South Texas Project Electric Generating Station P.O. Box 289 Wadsworth, Texas 77483

January 17, 2011  
U7-C-STP-NRC-110008

South Texas Project  
Units 3 and 4  
Docket Nos. 52-012 and 52-013  
Response to Request for Additional Information

Attached are responses to NRC staff questions included in Request for Additional Information (RAI) letter numbers 349 and 350 related to Combined License Application (COLA) Part 2, Tier 2, Sections 3.7 and 3.8. The attachments address the responses to the RAI questions listed below:

**Figure 3H.7-31: Enveloped, Broadened Horizontal Response Spectra for DGFOTs**

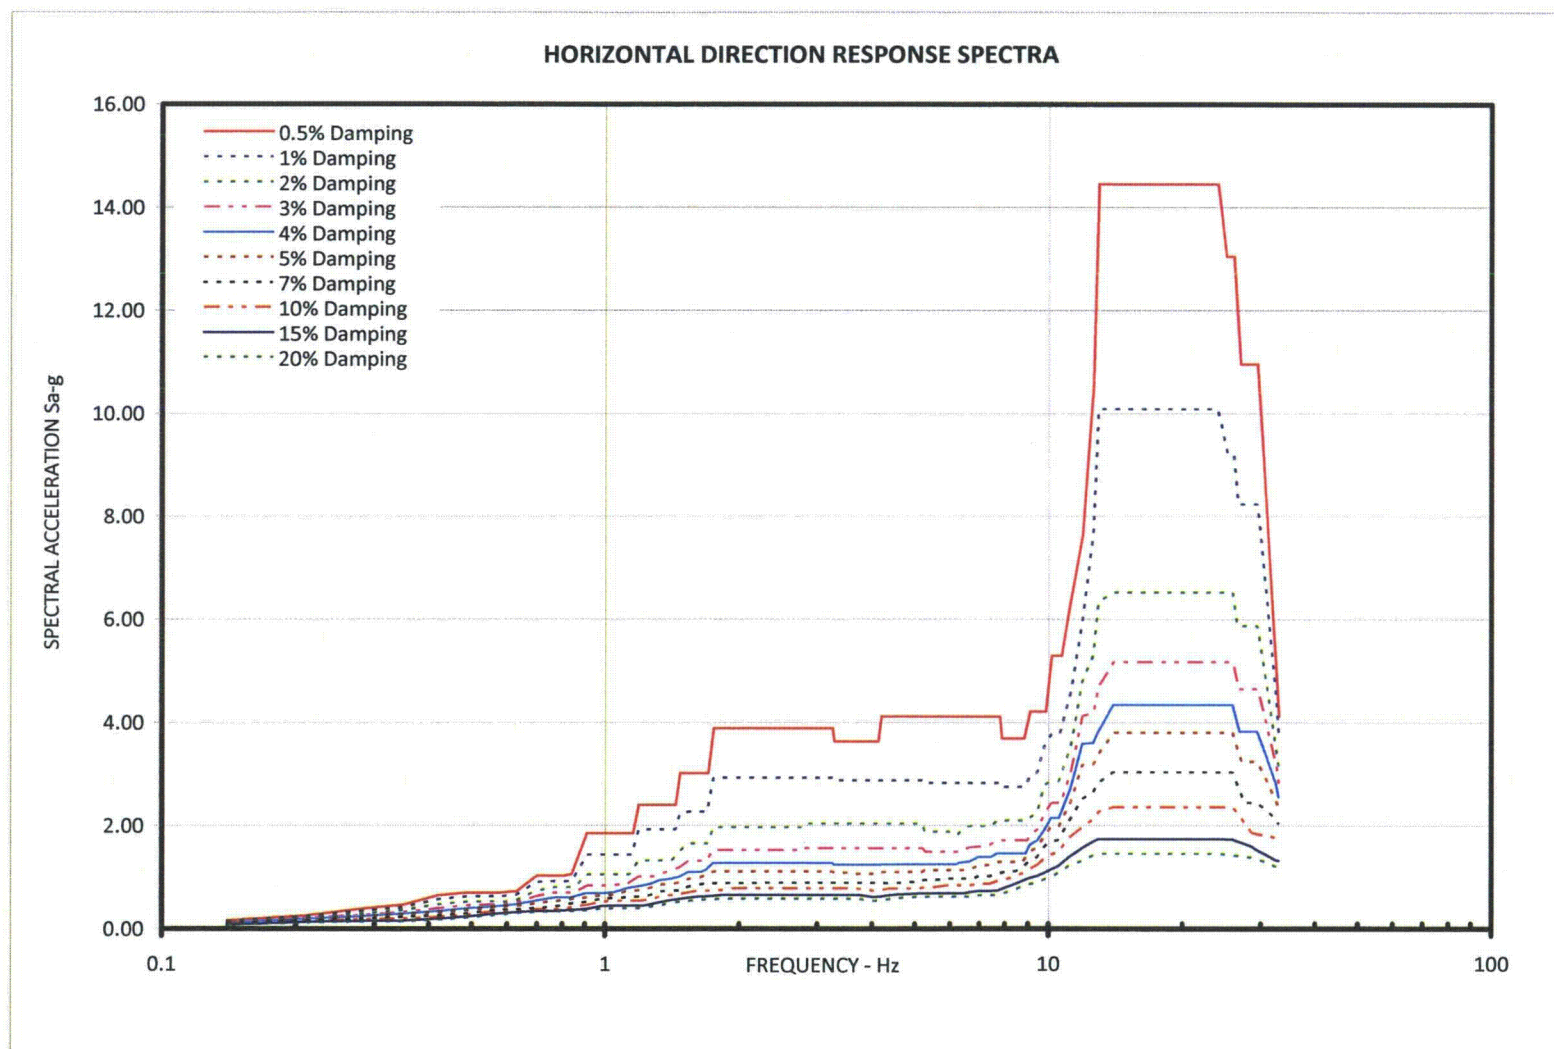
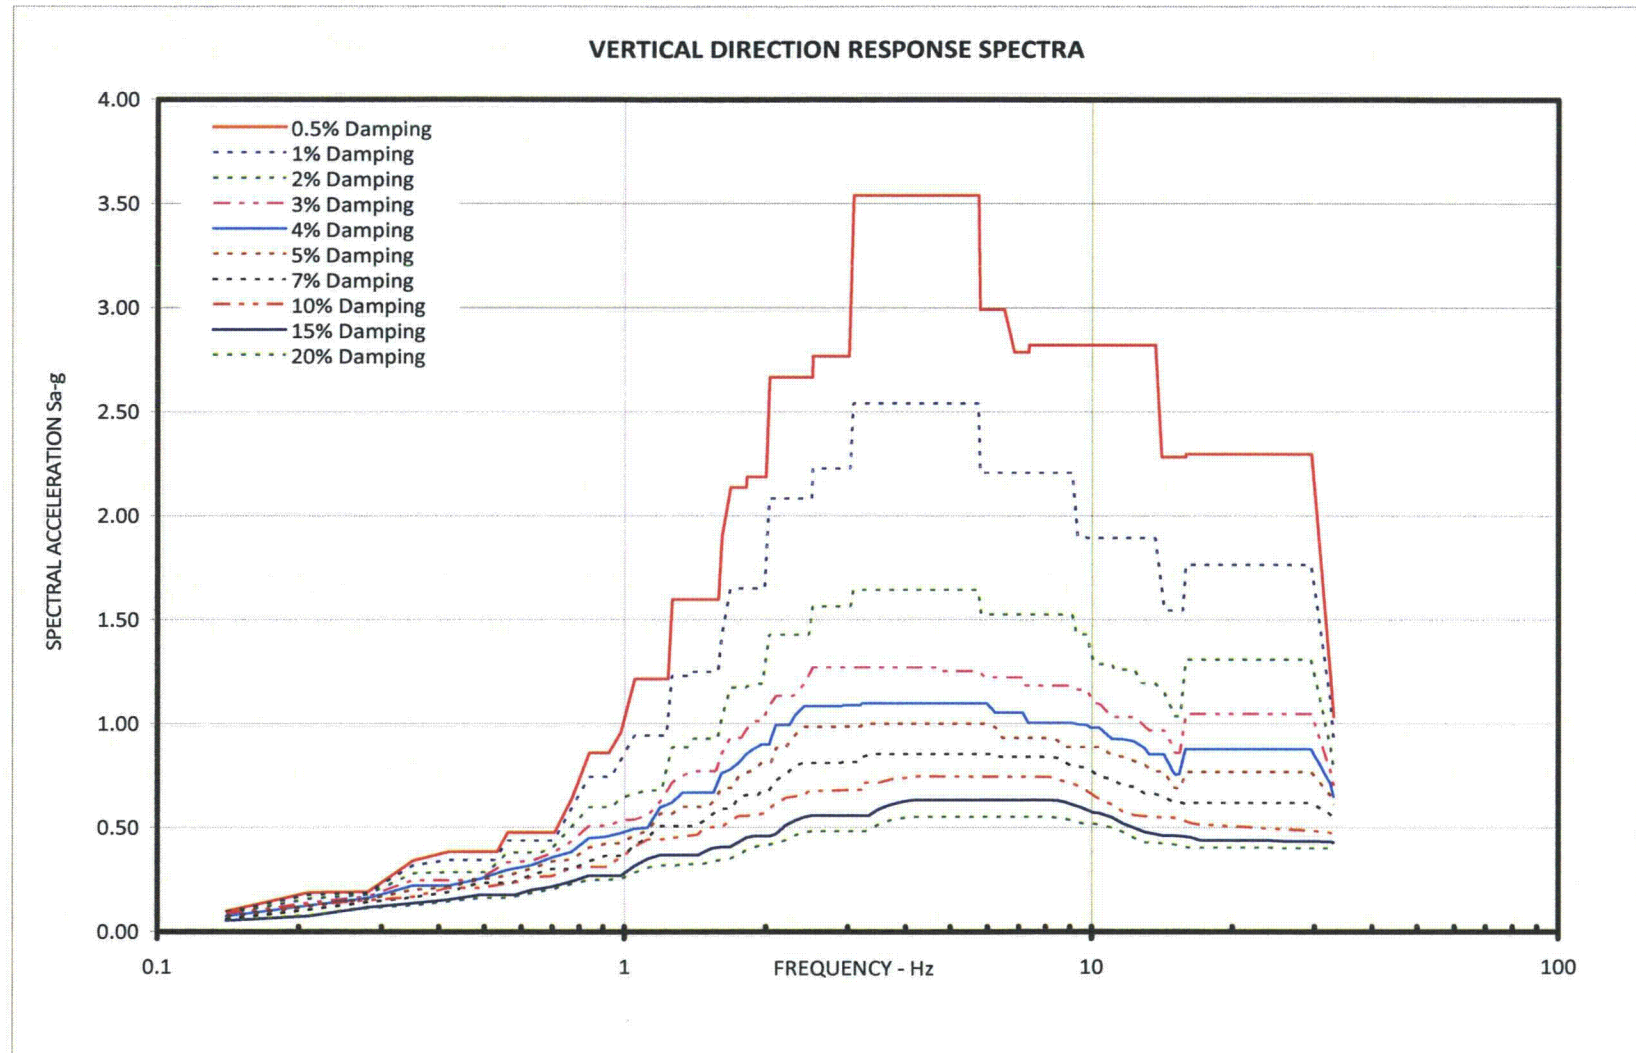
- (d) Describe in detail if there is any Category I tunnel structure for transporting Diesel Fuel Oil between DGFOVS and the Diesel Generator located in other buildings including its layout and configuration and seismic analysis and design method.

The corresponding in-structure response spectra obtained from the 2D SSI analysis and in-structure response spectra obtained from the 3D fixed base analysis described in parts A and B above are enveloped and peak widened by  $\pm 30\%$ . The 30% peak widening is used to cover any frequency shift due to the foundation soil flexibility, which is not included in the fixed base seismic analysis. The final widened in-structure response spectra for the horizontal and vertical directions of the DGFOTs and their access regions are provided in Figures 3H.7-31 and 3H.7-32, respectively. The spectra in Figures 3H.7-31 and 3H.7-32 provide the in-structure response spectra for the entire SGFOTs and their access towers at the two ends.
